Addendum: 1  
Date: 10/14/2024  
Project: Doermer School of Business  
Building Chillers Replacement - 2024  
Comm #: 24636

**Item #1: General Clarifications.**

# Doermer School of Business Building Chillers Replacement - 2024

TITLE:  
**MEZZANINE MECHANICAL  
DEMOLITION PLAN**

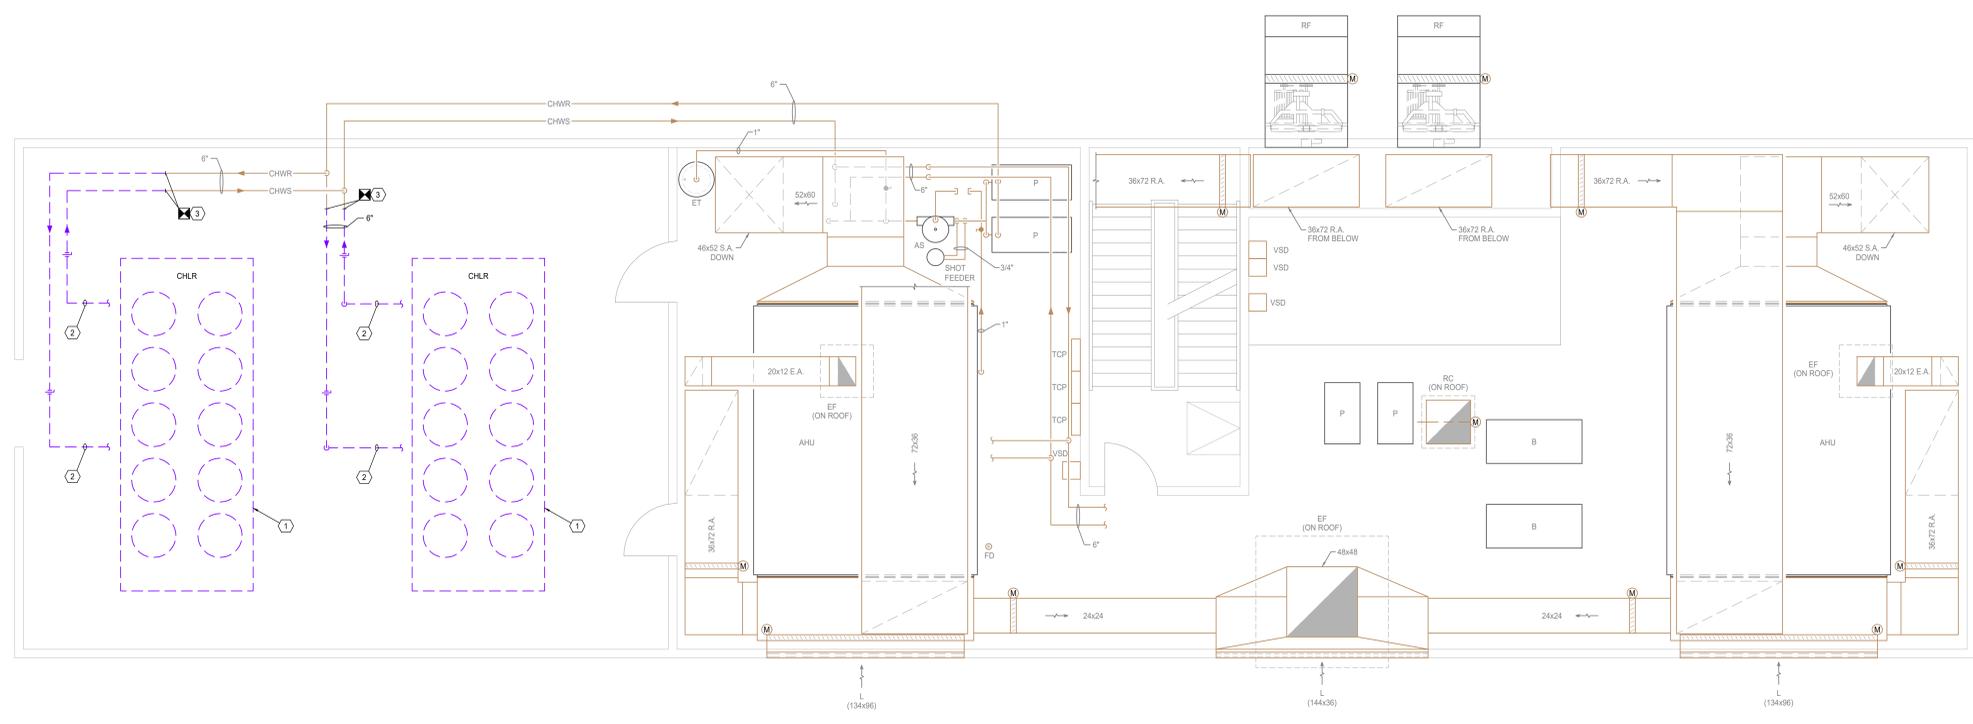
**Item #4: Drawing Sheet M101, "MEZZANINE MECHANICAL DEMOLITION PLAN".**

- A. Revised plan notes for removal of existing ethylene glycol. Pre-testing is not required, a water report was just performed by water sciences.

- MECHANICAL DEMOLITION PLAN NOTES**
- REMOVE EXISTING CHILLER COMPLETE INCLUDING ALL ASSOCIATED PIPING, WIRING, CONTROLS, ETC. EXISTING STRUCTURAL SUPPORTS TO REMAIN.
  - REMOVE EXISTING PIPING COMPLETE INCLUDING ALL ASSOCIATED HANGERS AND SUPPORTS.
  - CONTRACTOR SHALL FULLY EVACUATE GLYCOL SYSTEM IN ITS ENTIRETY AND SAVE FOR REUSE.
- UNDER AND ALTERNATE BID, CONTRACTOR SHALL FULLY EVACUATE CHILLED WATER SYSTEM IN ITS ENTIRETY. APPROXIMATE SYSTEM VOLUME = 730 GALLONS. DISPOSE OF THIS MATERIAL IN ACCORDANCE WITH ALL LOCAL/FEDERAL REQUIREMENTS. FLUSH SYSTEM WITH CLEAN WATER AND CIRCULATE TO REMOVE ALL RESIDUAL GLYCOL AND PUMP OUT AND DISPOSE OF THIS VOLUME ALSO. PROVIDE NEW PRE-MIXED 30% PROPYLENE GLYCOL. ALL CHEMICAL TREATMENT SHALL BE PERFORMED BY WATER SCIENCES (260-462-4655).

TITLE:  
**MEZZANINE  
MECHANICAL PLAN**

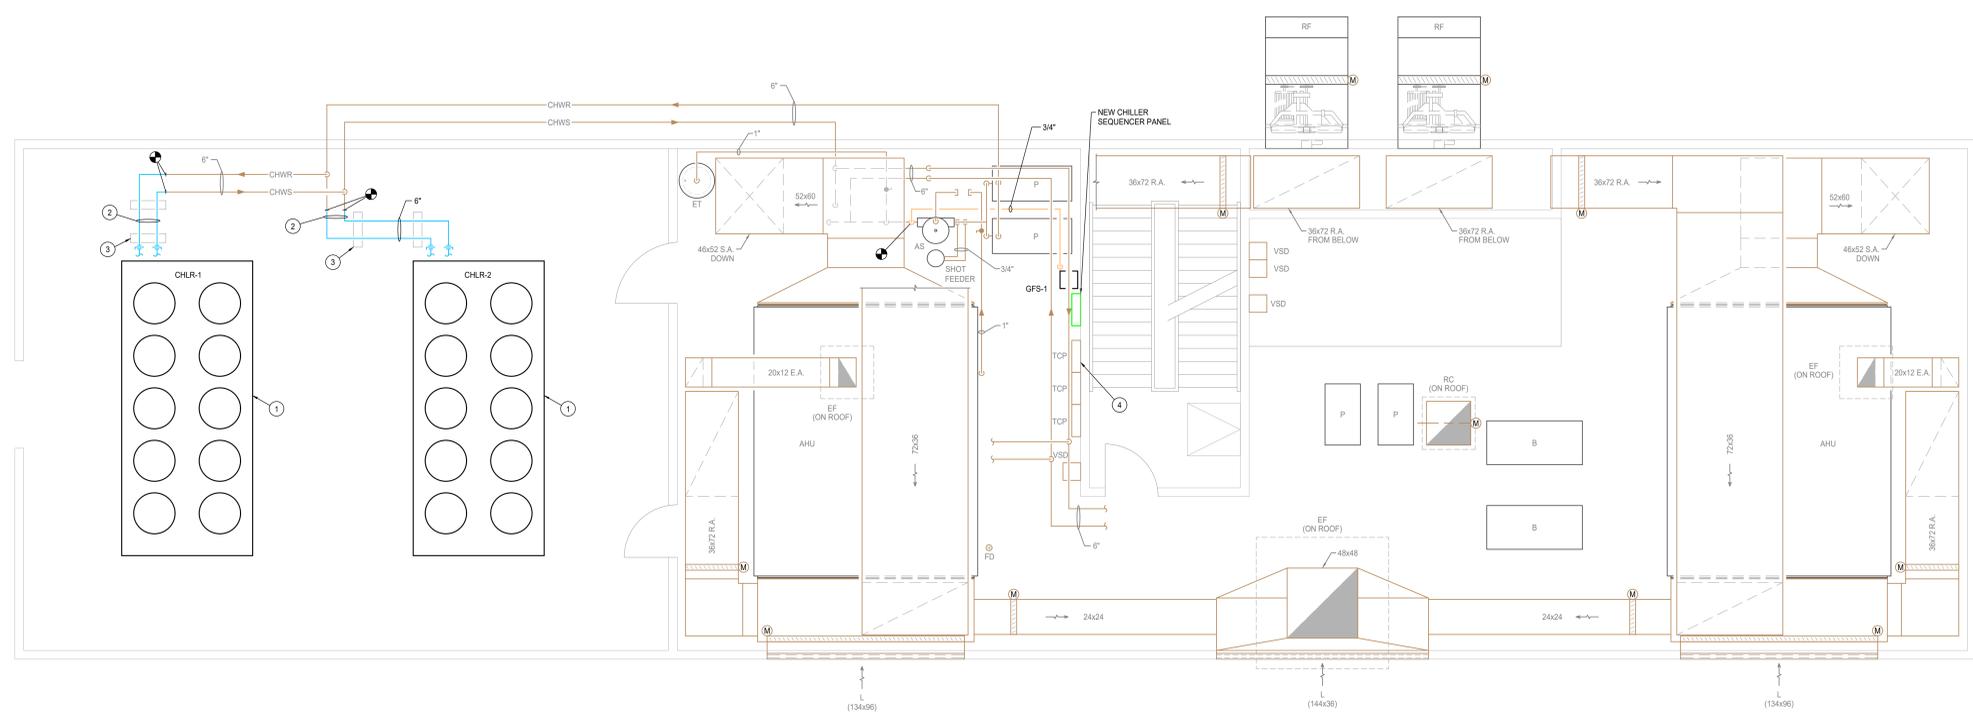
**Item #5: Drawing Sheet M201, "MEZZANINE MECHANICAL PLAN".**

- A. Revised double box notes for base and alternate bid with the glycol.

- CRANE SHALL BE SCHEDULED SUCH THAT NO LOADS ARE MOVED ABOVE THE OCCUPIED BUILDING DURING OPERATIONAL HOURS. COORDINATE EXACT DATE AND TIME WITH THE OWNER AT LEAST 1 WEEK IN ADVANCE.
- FILL SYSTEM WITH SALVAGED 30% E.G. AND ADD GLYCOL AS REQUIRED TO REACH 35% E.G.
- UNDER AN ALTERNATE BID, CONTRACTOR SHALL FULLY EVACUATE CHILLED WATER SYSTEM IN ITS ENTIRETY. APPROXIMATE SYSTEM VOLUME = 730 GALLONS. DISPOSE OF THIS MATERIAL IN ACCORDANCE WITH ALL LOCAL/FEDERAL REQUIREMENTS. FLUSH SYSTEM WITH CLEAN WATER AND CIRCULATE TO REMOVE ALL RESIDUAL GLYCOL AND PUMP OUT AND DISPOSE OF THIS VOLUME. ALSO, PROVIDE NEW PRE-MIXED 35% PROPYLENE GLYCOL. ALL CHEMICAL TREATMENT SHALL BE PERFORMED BY WATER SCIENCES (260-485-4665).

**CHILLED WATER FLOW DIAGRAM**  
SCALE: NTS

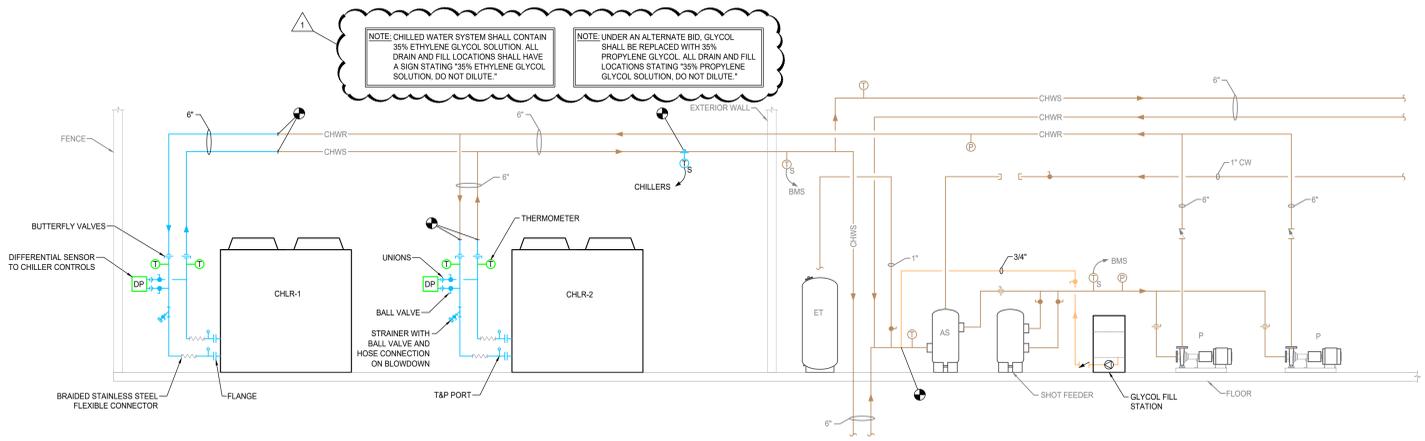
**Item #6: Drawing Sheet M401, "MECHANICAL DETAIL SHEET".**

- A. Revised double box note on the new chilled water flow diagram to reflect glycol on base and alternate bid.
